Pulaski County Schools
Energy Savings and Performance Contract
Addendum #2
March 25th, 2022

CMTA Contact:	Megan Brangers
Email:	MBrangers@cmta.com
Cell Phone:	502-919-1521

The following information supersedes or is in addition to information released in the Contract Documents dated March 11th, 2022 and addendum 1 dated March 18th, 2022.

M2-5.1

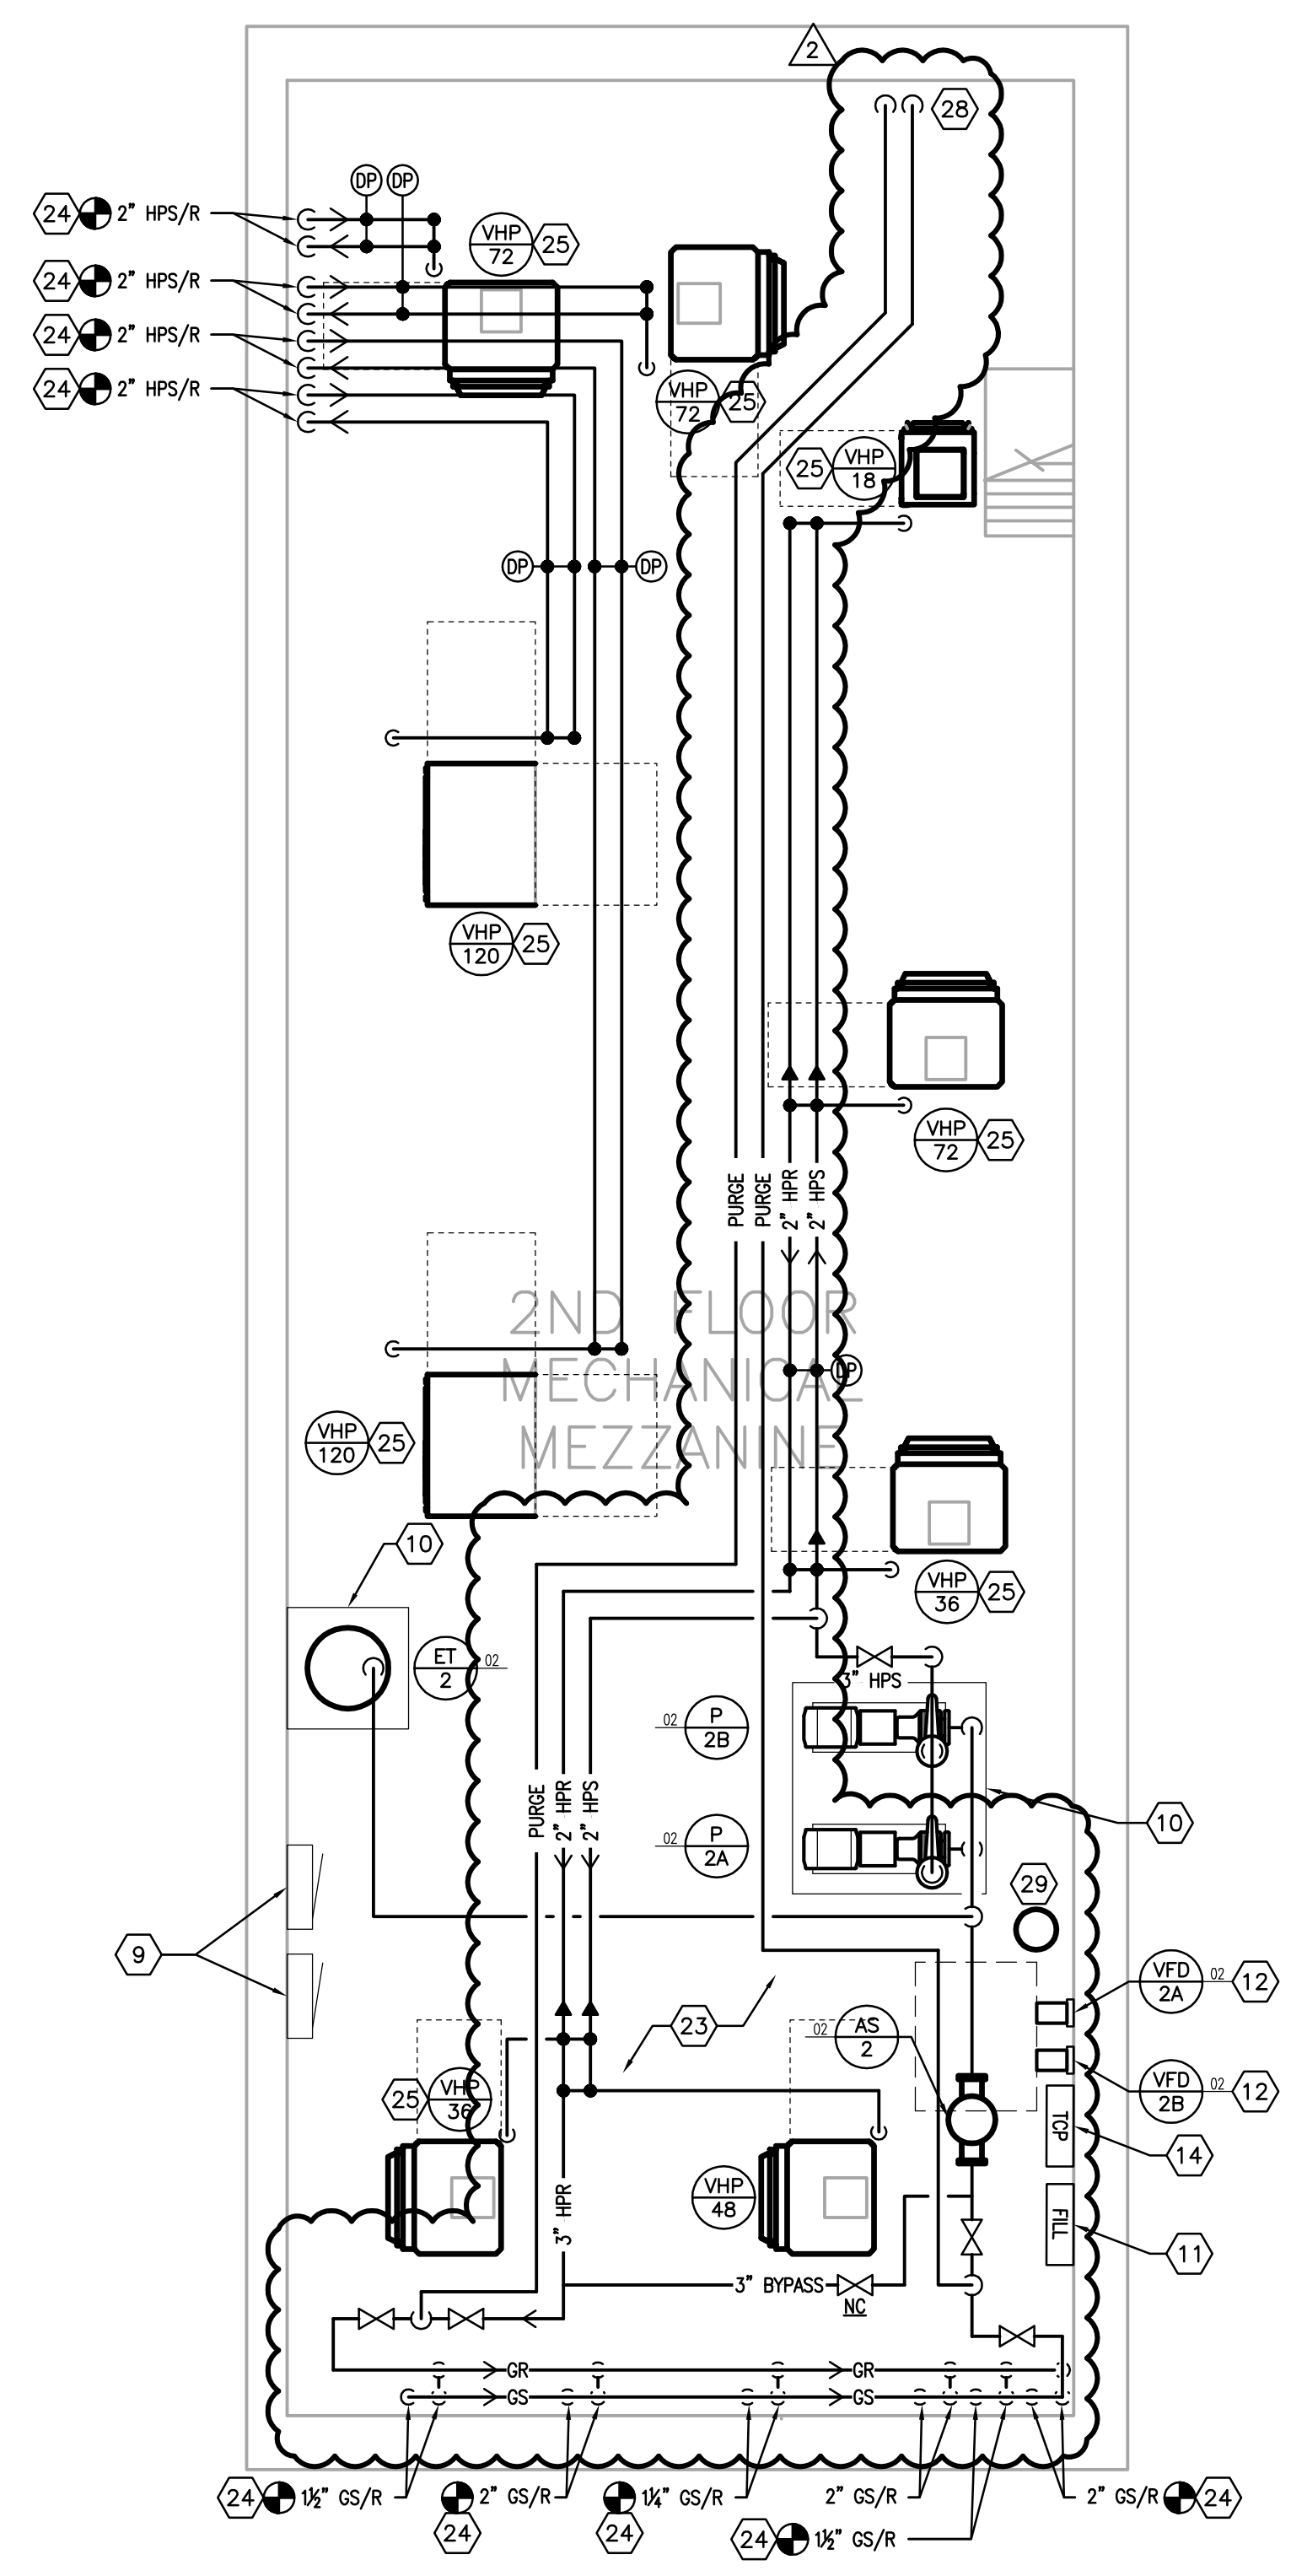
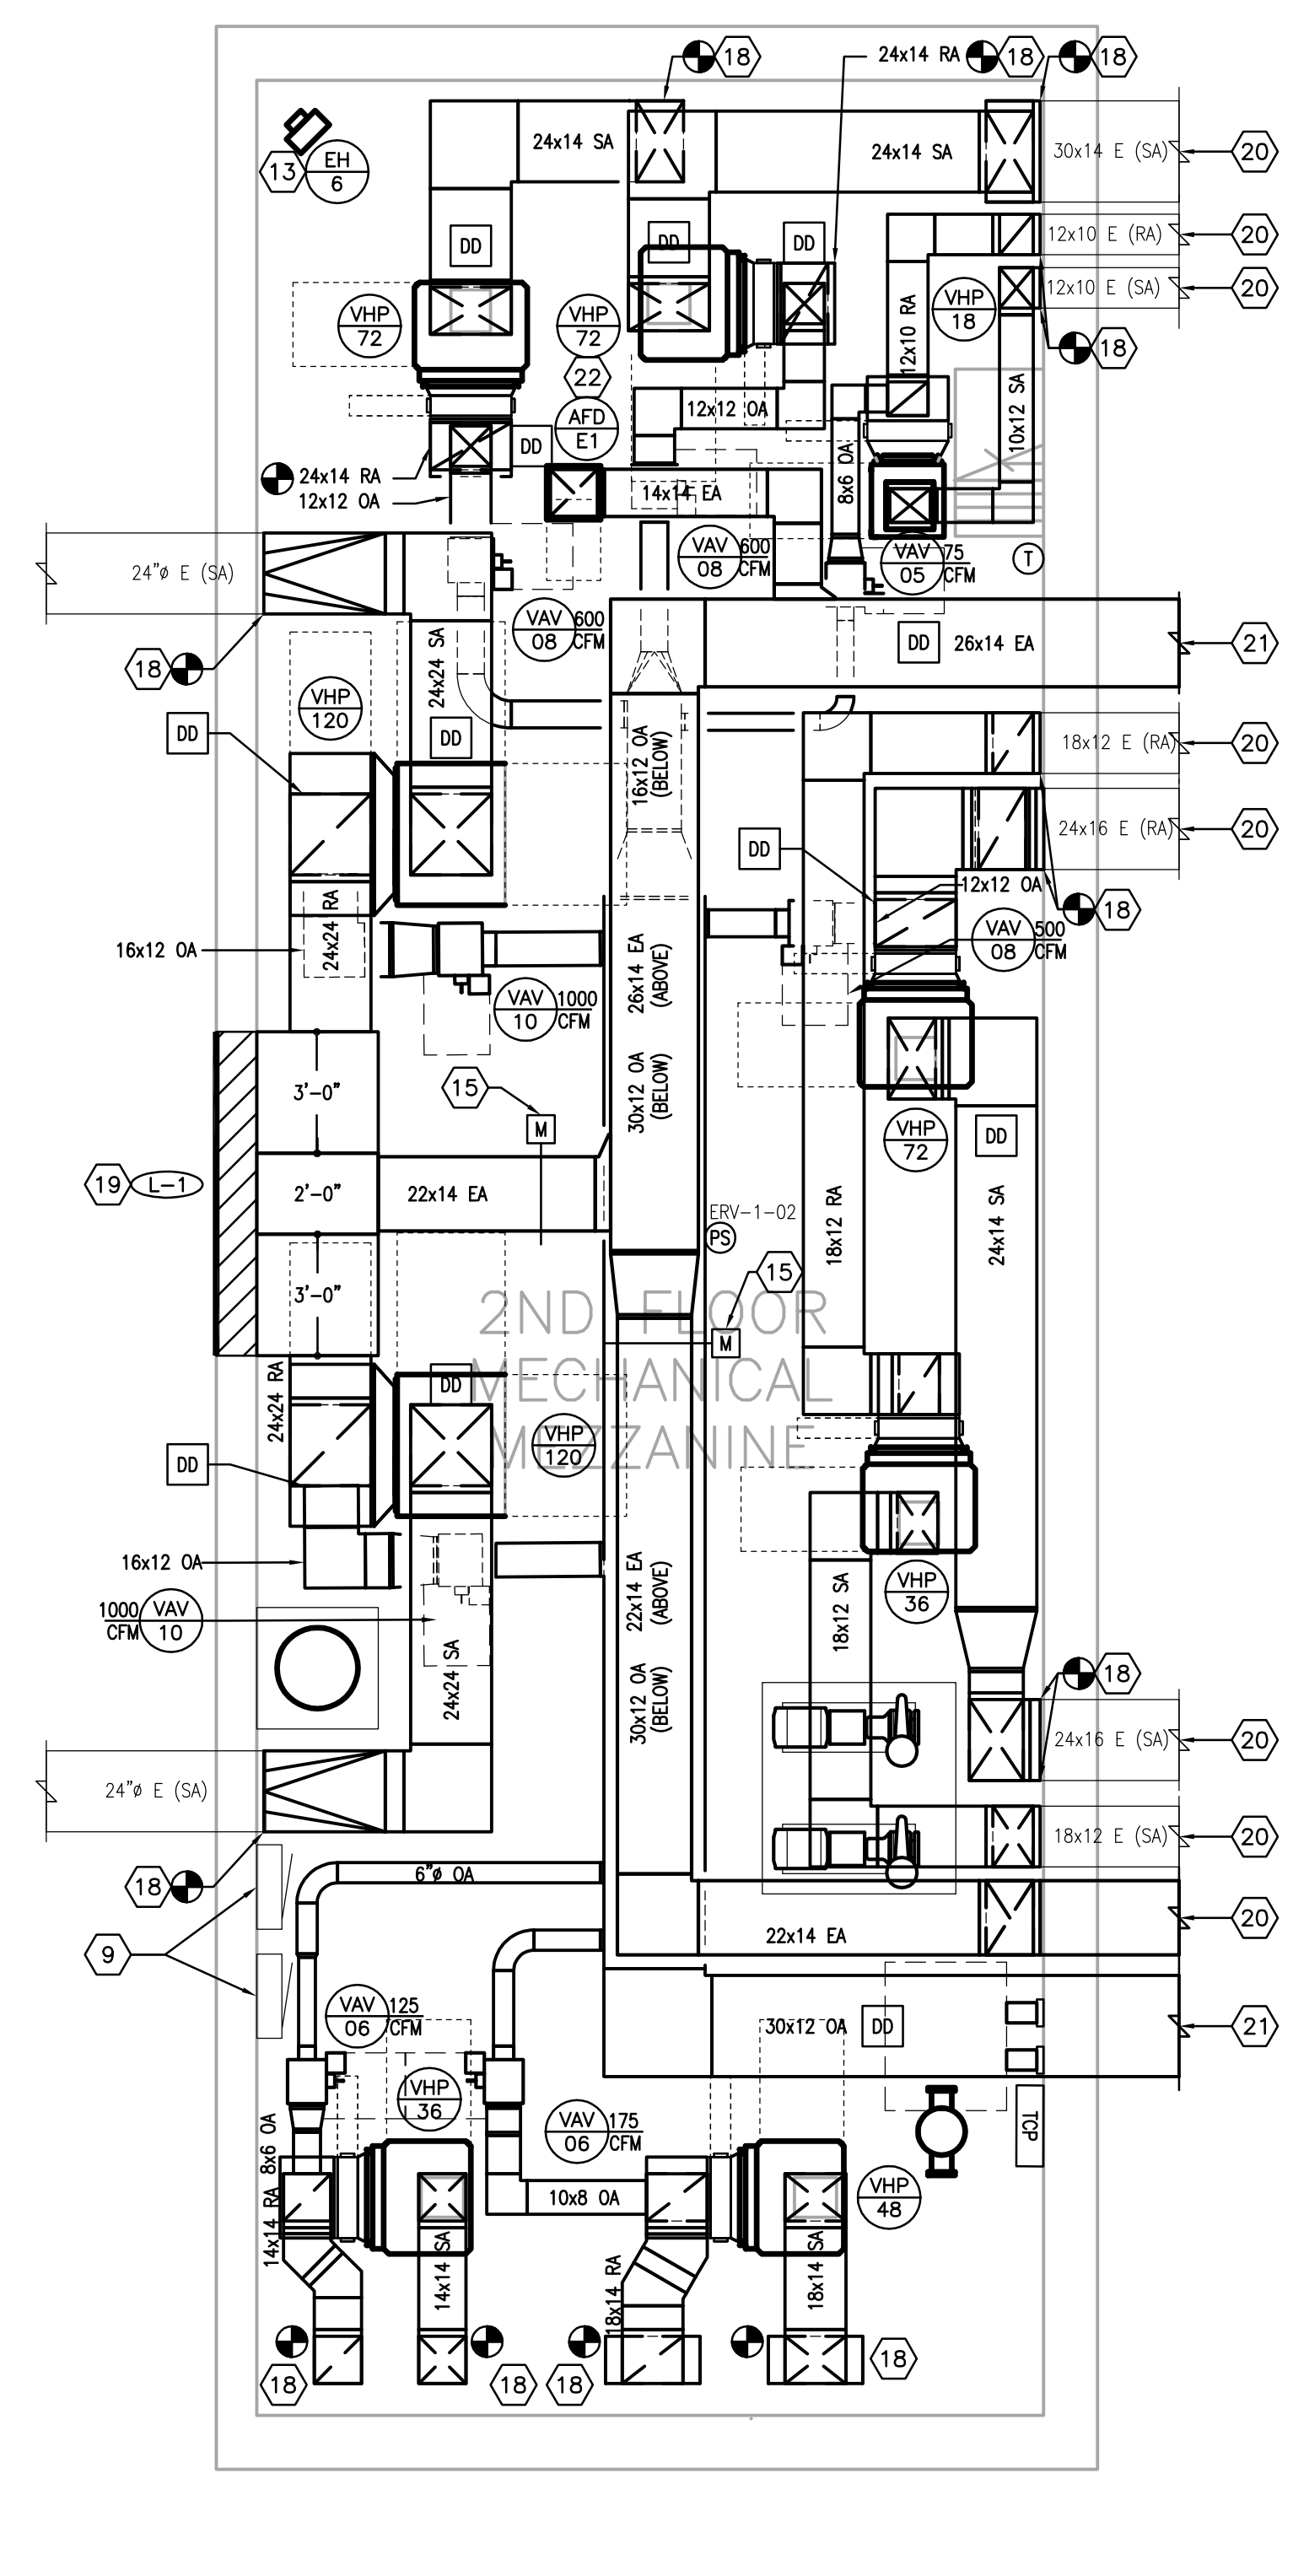
15. Drawing M2-5.1

- a. Refer to Mechanical Mezzanine Hydronics for revised geothermal and heat pump piping. Add geothermal wellfield bypass and purge ports. Add 5-gallon pot feeder.
- b. Refer to 'Geothermal Piping Schematic - Mechanical Mezzanine' for updates. Add geothermal wellfield bypass and purge ports. Add 5-gallon pot feeder.
